## Discontinuation Notice for EVQ-9P701K Light Touch Switch

PDN.PG26.04.23.2015

## Details

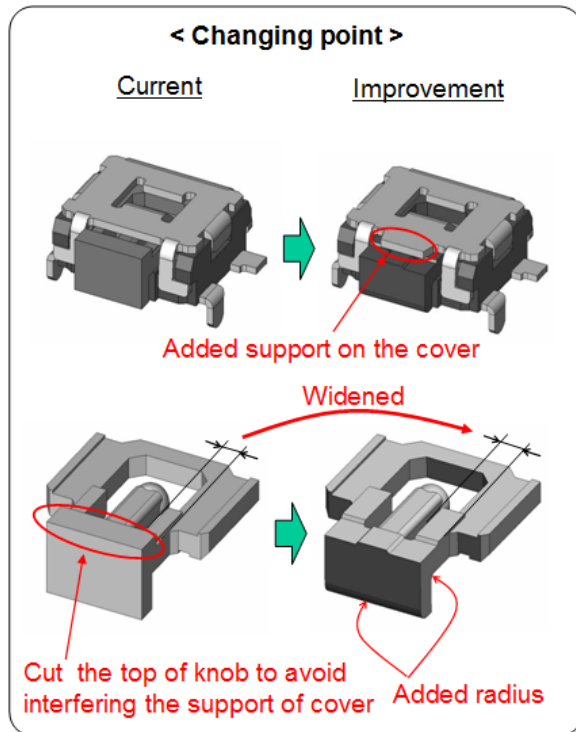
<b>Effective Date:</b>	April 23, 2015
<b>Last Time Buy Date:</b>	June 30, 2015
<b>Last Eligible Ship Date:</b>	August 17, 2015
<b>Discontinuation Details:</b>	EVQ-9P701K shall be replaced with the improved part number EVQ-9P701P. See details on the next page for the improvement changes. EVQ-9P701K shall no longer be available for purchase after above effective date.
<b>Suggested Replacement:</b>	EVQ-9P701P
<b>Affected Part Numbers:</b>	EVQ-9P701K
<b>Datasheets:</b>	See Attached
<b>Notes:</b>

After the P.W.B is horizontally fixed as shown in figure 1, pressure is applied to the switch gradually by push-pull gauge and the force was measured when the push plate broke down.

Improvement	Current
1	8.6	5.1
2	9.2	5.3
3	9.6	4.7
4	9.8	4.9
5	9.4	4.5
6	9.1	4.6
7	8.8	4.8
8	8.7	5.0
9	8.9	4.6
10	9.1	4.6
Ave	9.12	4.81
max	9.8	5.3
min	8.6	4.5
$\sigma$	0.39	0.26

Push plate strength of improvement : 8.6 – 9.8 N
